STANDARD DEPARTURE CHART-INSTRUMENT

RJFN / NYUTABARU

NIPPO SEVEN DEPARTURE

SAITO ONE DEPARTURE

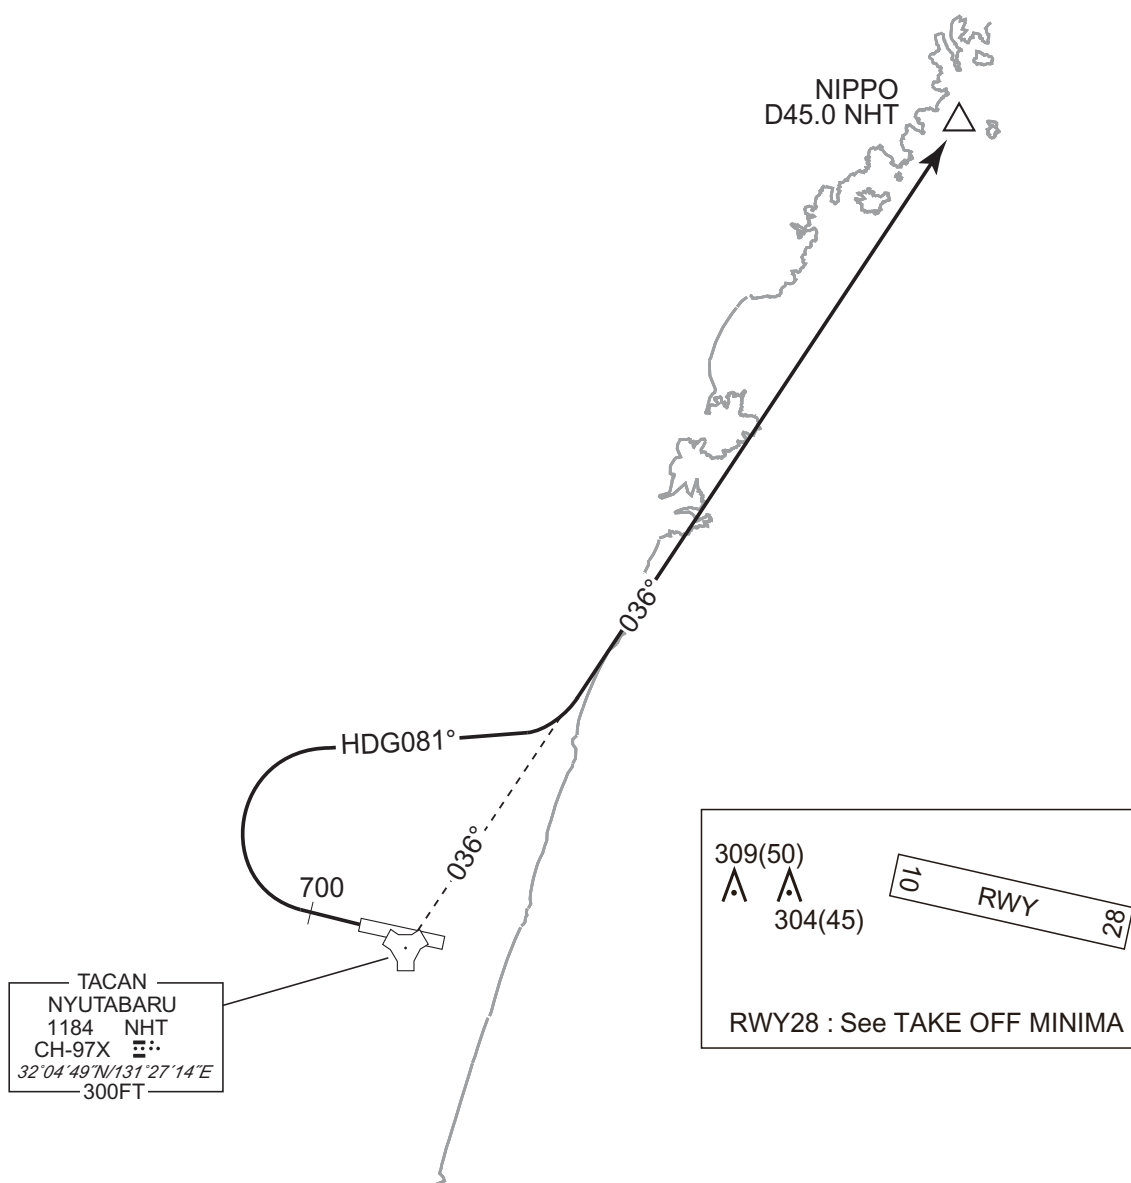
CHANGE : New PROC.

TENSO ARRIVAL

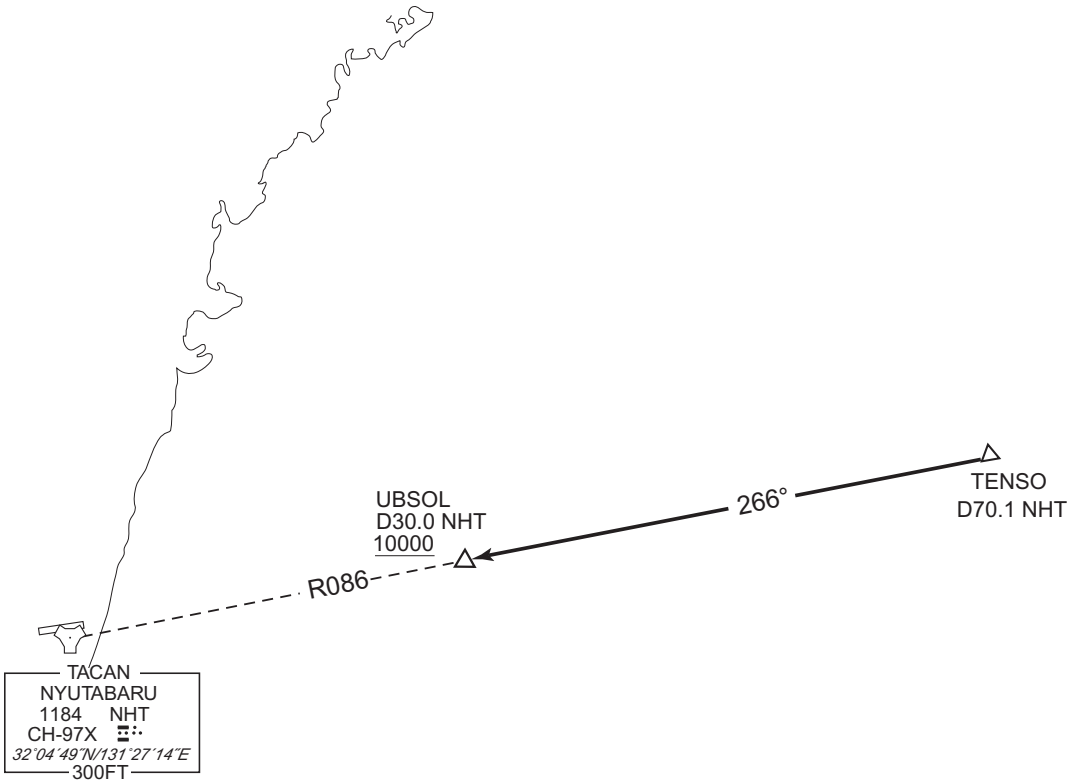
CHANGE : PROC course. UBSOL established. ALT restriction.

From over TENSO, via NHT R086 to UBSOL.
Cross UBSOL at or above 10000FT.

TACAN Z RWY28

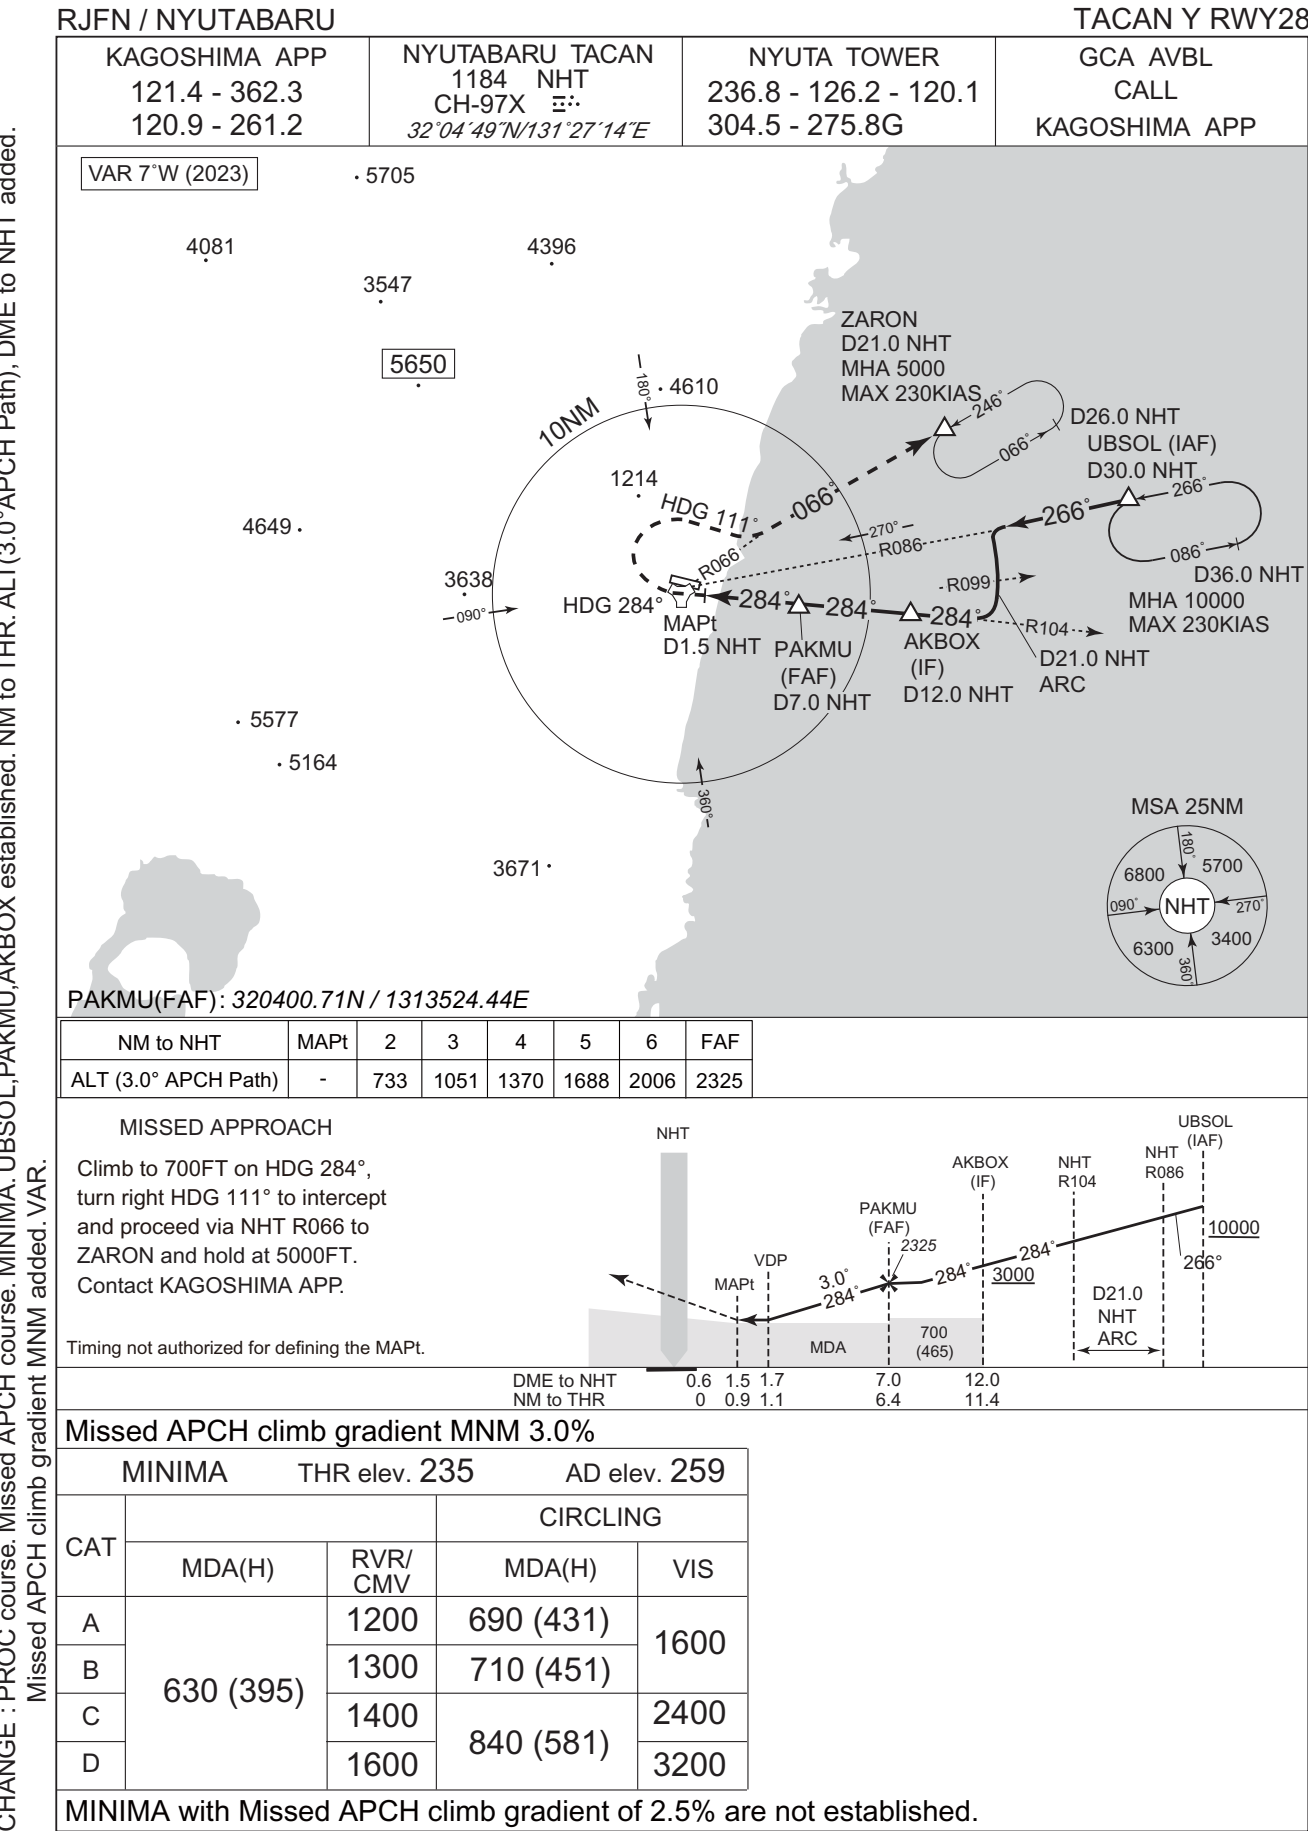
CHANGE : PROC course. Missed APCH course. MINIMA. PAKMU,AKBOX established. NM to THR.ALT(3.0°APCH Path), DME to NHT added. Missed APCH climb gradient MNM added. VAR.

Timing not authorized for defining the MAPt.

MINIMA with Missed APCH climb gradient of 2.5% are not established.
